For: Cetti Ltd.

Proposed Residential Development,
Scairt Cross.

Stage 1 and 2 Road Safety Audit

July 2024

Figure 1.2 Development site layout (c: O'Mahony Pike Architects)

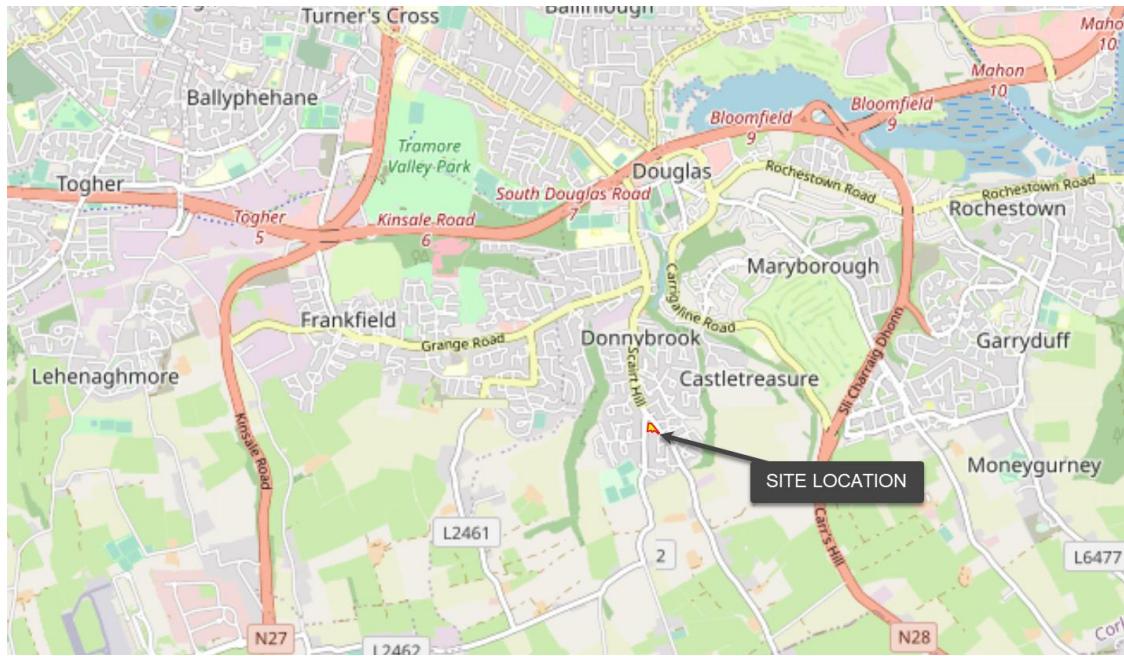
Appropriate stop road marking are not shown at the proposed entrance junction, though the associated signage is indicated. Failure to provide appropriate road markings may cause confusion with regard to priority at the entrance junction, leading to collisions between passing vehicles and vehicles exiting the development.

Public Lighting design details were not provided to the Audit team. Given that the proposed development ties into an existing road, and public lighting scheme, particular care should be taken to ensure that the development public lighting is designed appropriately and sympathetic to the existing street lighting. Failure to adequately illuminate the proposed junction and pedestrian or greenway accesses, and any road crossings may lead to collisions involving vehicles travelling along the public road and colliding with existing cars or vulnerable road users.

The proposed development entrance junction does incorporate tactile paving or dropped kerb or raised table. Failure to provide appropriate warning paving may lead to visually impaired users over-stepping the footpath edge and unknowingly entering the trafficked road space leading to collisions with passing vehicles.

Provide appropriate road marking at the development entrance, in accordance with relevant design standards.

Review the public lighting design in the vicinity of the proposed entrance and also nearby existing uncontrolled crossing to ensure compliance with relevant design standards. Provide appropriate public lighting for the scheme, referencing the adjoining road scheme lighting. Provide adequate lighting at pedestrian crossings.

Provide appropriate tactile paving and dropped kerb or raised table at the crossing location in accordance with relevant design standards.
